**Tech Tip** S-TT-0082-14

# Rear Combination Lens Service Tips

2013-2015 FR-S

# Gasket change Detail

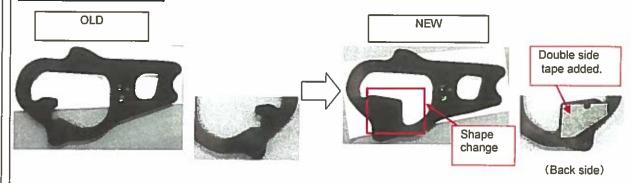
Effective 9/2013 the rear combination light housing and gasket were changed to reduce the possibility of insect intrusion into the rear combination light housing.

This Tech Tip is being published as a reference for using current level gaskets with previous level rear combination lights.

Do not use prior level gaskets on newer tail lights. It is permissible to install current level gaskets with previous level tail lights.
